STAFF RECOMMENDATION 208 Broadway March 20, 2019

Application: Signage/ Violation
District: Broadway Historic Preservation Zoning Overlay
Council District: 19
Zoning: DTC
Map and Parcel Number: 09306211100
Applicant: R Hospitality, LLC/ Redneck Riviera
Project Lead: Jenny Warren, jenny.warren@nashville.gov

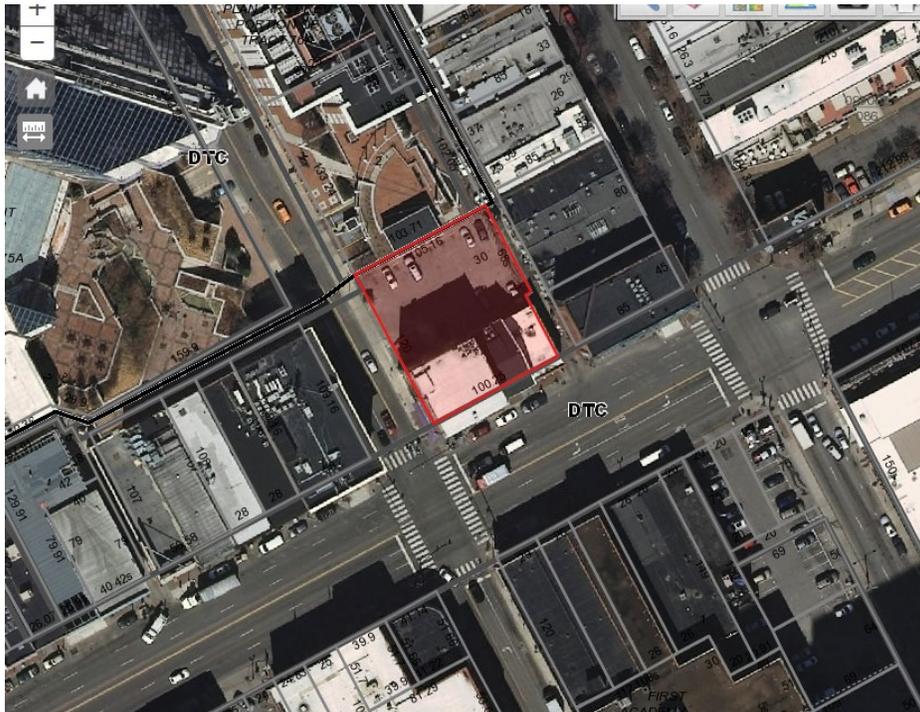
Location: The signage is located on the right wall of the building, on the first level, below the window sill of the 2nd level. The applicant would like to request to maintain the signage in the current location. Staff finds that the signage does not meet the design guidelines for location as it is not located on the upper level.

Staff recommends removal of the sign with the condition that the method of removal is approved by staff; finding that the sign does not meet section IV. *Signage* of the design guidelines, specifically the location of the sign. Staff further recommends approval of the same sign relocated to the 2nd level so that the entirety of the sign is above the window sills on the 2nd level; finding that the current sign meets all other design guidelines and the proposed upper level location would also meet the design guidelines for signage.
